<b>NE-LCP Contractor/Supplier</b>	Contract or Purchase Number and Description: CH0007-001 – Intake & Powerhouse, Spillway & Transition Dams		Contractor/Supplier Name: ASTALDI CANADA INC.	
	Document Title: MUSKRAT FALLS - DRAFT TUBE UNIT 2 OUTLET - CIVIL GENERAL REPORT - MAN BASKET INSPECTION		Total Number of Pages Incl. Front Sheet 22	
	Contractor Document Number: A-DT000-NA-CV-D31-200-01		Revision Number: 0	
	Supplier Document Number:		Revision Number:	
	NE-LCP Document Number: MFA-AT-SD-331A-EN-A99-0002-01		NE-LCP Issue Number: B1	
	Approver's Signature: Giuseppe Mazzucco 		Date (dd-mmm-yyyy): 21-Jun-2016	Review Class:
<u>Comments:</u>			Equipment Tag or Model Number:

<b>Completed by LCP Representative</b>				<b>Completed by LCPDCC</b>	
Document Title:				Record Number:	
MUSKRAT FALLS – DRAFT TUBE UNIT 2 OUTLET – CIVIL GENERAL REPORT – MAN BASKET INSPECTION					
NE-LCP Document Number:	Revision:	3 <sup>RD</sup> Party Document Number:	Revision:	Transmittal Number:	
MFA-AT-SD-331A-EN-A99-0002-01	B1	A-DT000-NA-CV-D31-200-01	0		
LCP Department of Origin:		Purchase Order/Contract Number:		Transmittal Date:	
Project Delivery Team		CH0007 – Construction of Intake and Powerhouse, Spillw

Figure 1: Major CEI formwork elements damaged in the collapse.

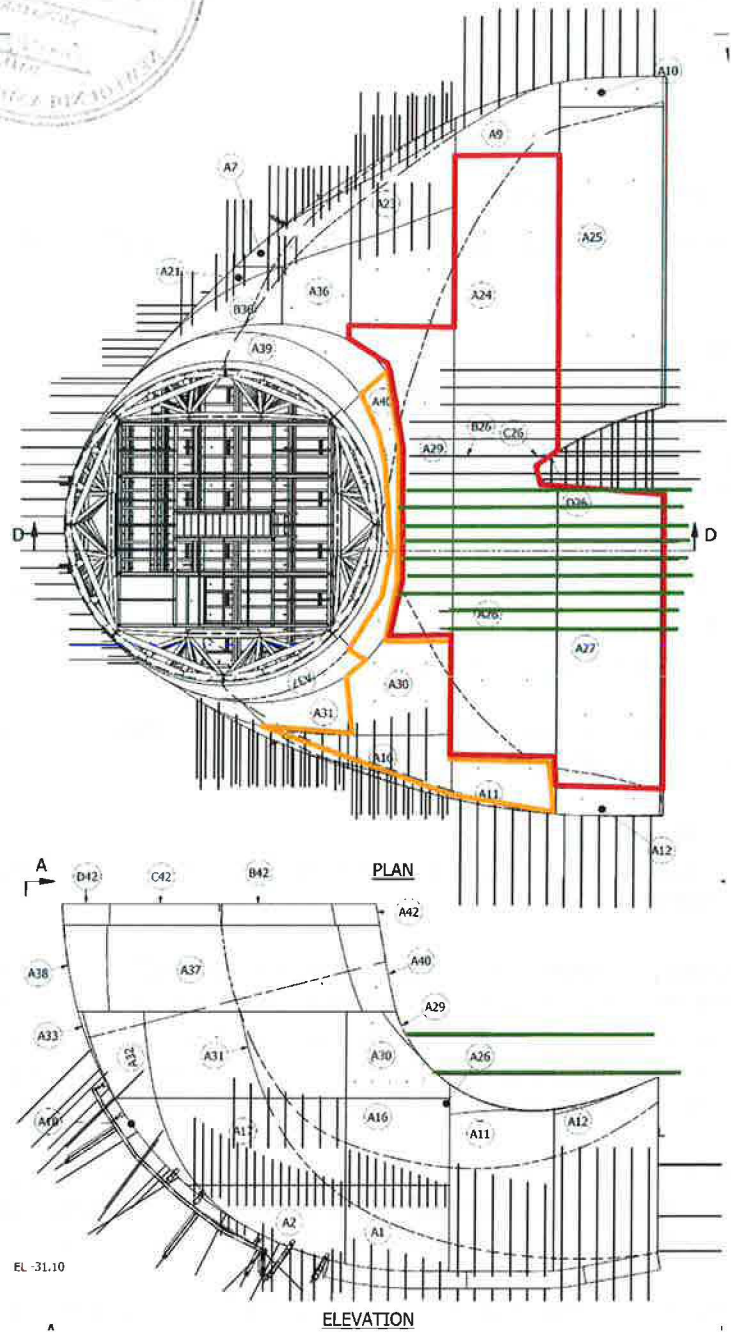
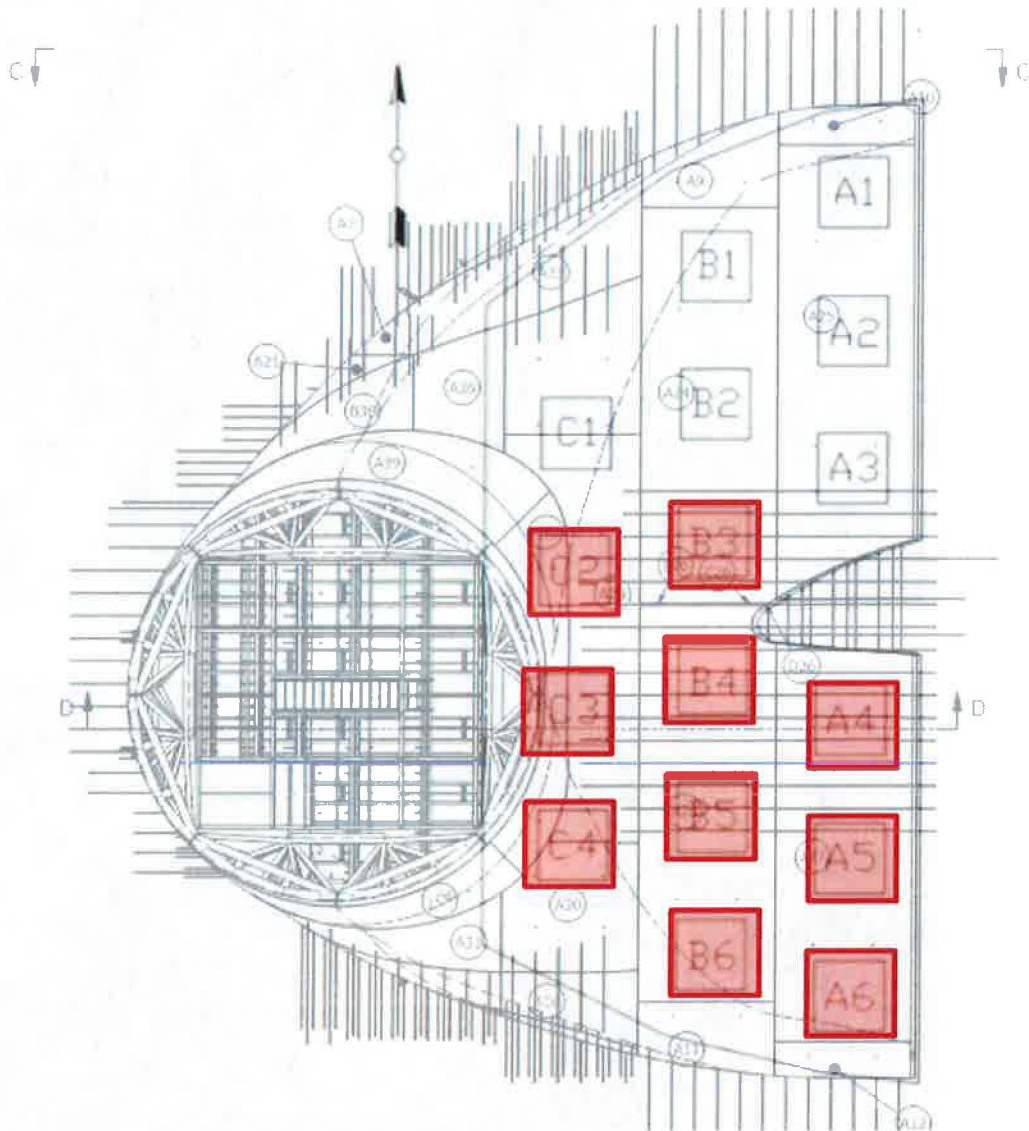
LCP Representatives: Stephen Nicholas, John Mulcahy, Ed Bush (consultant), Sean Dingley (aDB Engineering)			Lead Reviewer: Stephen Nicholas		
Item No.	Section/Paragraph /Page/Sheet	Comment	Response	Status	
1	General	LCP is returning this document code 02. Please revise and resubmit.			
2	Figure 1 and Figure 2	Figure 1 indicates major damage to formwork elements on the north side including towers B1 and B2, while figure 2 does not indicate damage to the towers in this area. It is not clear if it was possible to see the status of those northern towers during the inspection.			
3	General	Since release of this report, it is understood further inspection has taken place on the north side from inside the draft tube. Will this report be updated with this information or will this be captured elsewhere?			
4	Damaged Formwork Elements	“Formwork and shoring element that are repaired and/or reused should be inspected by a qualified person to ensure...” This statement appears to be outside the scope of this document?

Figure 12: Holes from failure lower row of ties filled with concrete

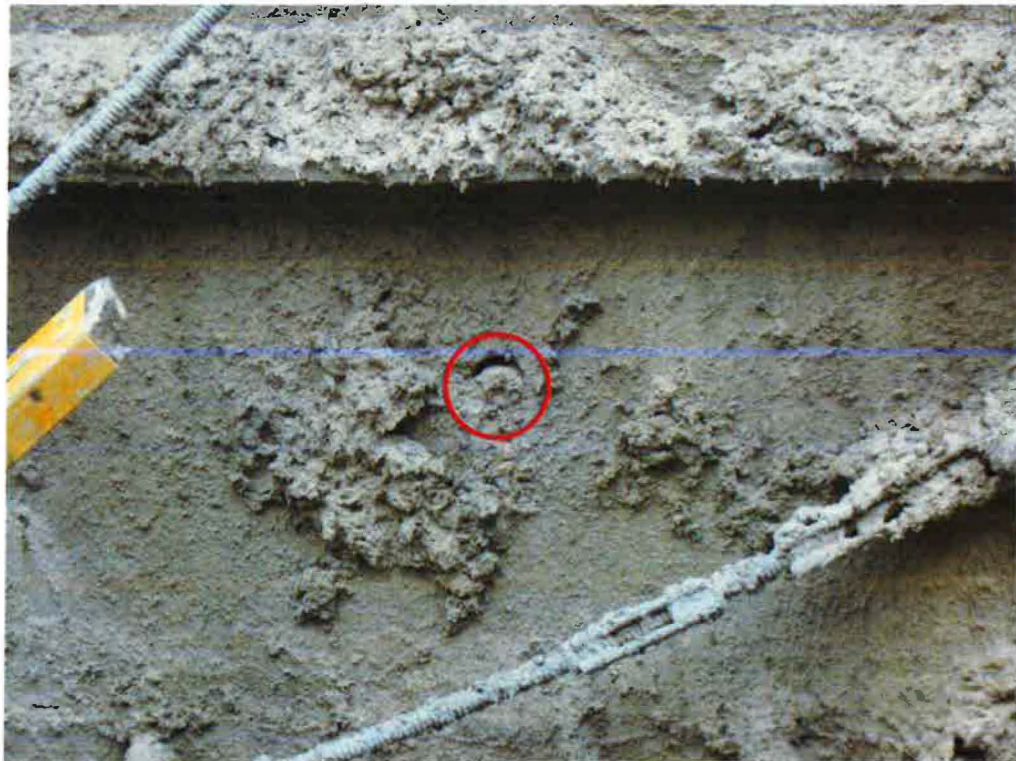
Item No.	Section/Paragraph /Page/Sheet	Comment	Response	Status
5	Coil Rod, pg 8 and 9	Higher resolution photos of the coil rod anchors and holes should be provided. Suggest comparing number of tie rods that can be visually confirmed with design. Should discuss presence of spalled concrete. Please include observations about holes that filled with concrete, it appears the bottom are filled while the upper are empty?		
6	Figure 13	Please identify these ties, are they the lower or upper level?		
7	Built-in-place formwork pg 15	Is there any evidence to indicate how the ties for the bulkhead were installed?		
8	Conclusion	"The coil rods tying panel A29 to pour D2USB-02 appear to have been in place at the time of the failure." No basis for this statement based on evidence presented in this report. It appears that some tie rods were installed but others will require a more detailed investigation to confirm. A full investigation of this area shall be performed once concrete can be cleaned off during remediation.
